Re: Revised Draft Environmental Impact Report for the Cabrillo Port Deepwater Port
Deepwater Port License Application

The U.S. Department of the Interior (DOI) has reviewed the LNG Deepwater Port Revised Draft Environmental Impact Report (Revised DEIR) for the Cabrillo Port LNG Deepwater Port. The U.S. DOI Minerals Management Service (MMS) reviewed sections of the document according to their areas of expertise, primarily regarding issues related to MMS issuance of a right-of-way (ROW) permit under 30 CFR 250.1009 for the LNG pipelines associated with Cabrillo Port and commensurate environmental analyses to support the ROW permit. A general review was conducted as well in accordance with reviews of the previous DEIR. While some previous comments seem to be rectified in the Revised DEIR, issues relating to pre-lay geological and geotechnical surveys and environmental impacts associated with those operations appear to be lacking in this Revised DEIR. The MMS will continue to work with the United States Coast Guard to rectify these issues in the Final EIS/EIR (FEIS/R). The comments that follow identify specific areas that we think could be corrected, further clarified, or where supple

Navy Proposed Tanker Routes Based on Cumulative Impacts

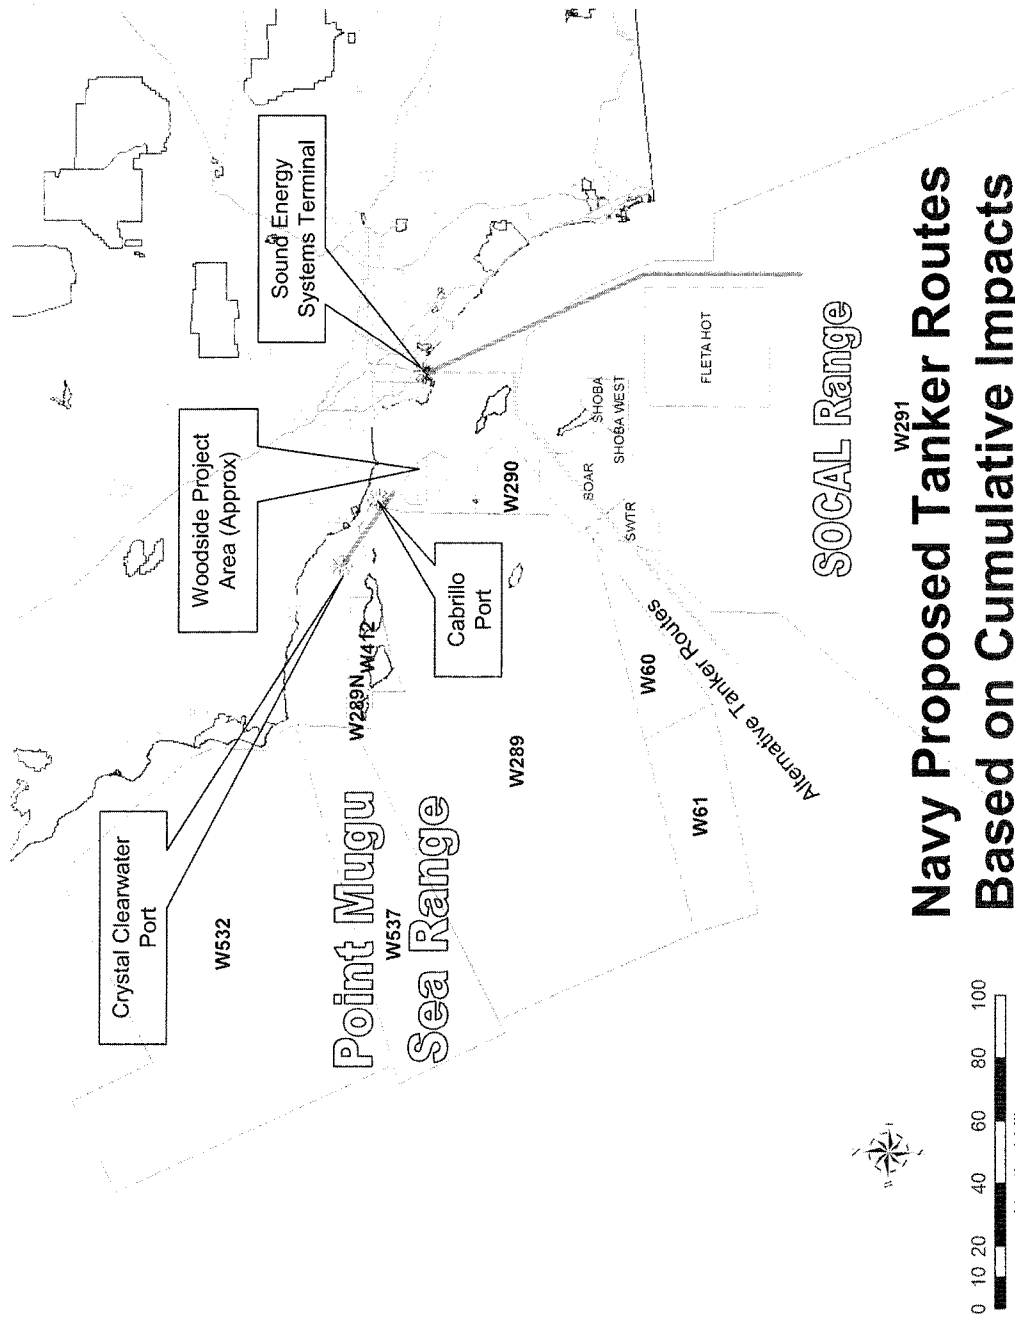
#	Page	Reference	Reviewer	Comment
1.	ES-26	4.3	S. Donovan	Please add discussion of cumulative impact of LNG tanker routes through PT Mugu and SOCAL sea ranges. Request that tanker routes be revised as shown in the attached map.

11	4.3-46 and Fig 4.3-2		NAVAIR/Tony Parisi	<p>Please revise text and map to reflect revised tanker route and to include the two routes labeled Crystal/Woodside/Crystal alternatives #1 and #2 on the attached map in this section or in the cumulative analysis.</p>
12	4.3-10/11	28-7	NAVAIR/Tony Parisi	<p>This should be changed to read: "The routing for LNG carriers approaching the FSRU is shown in Figure 4.3-2. Normally, the LNG carrier Master would select the approach and departure from the routes in accordance with Cabrillo Port's Marine Operations Manual..." Add the following at the end of the paragraph, "Although infrequent, Navy operations could preclude use of either or both routes for periods up to several hours. In those cases, the LNG carrier Master will adjust to ensure there is no impact on Navy operations."</p>

See the response to Comment F200-1.

Section 4.20 has been updated.
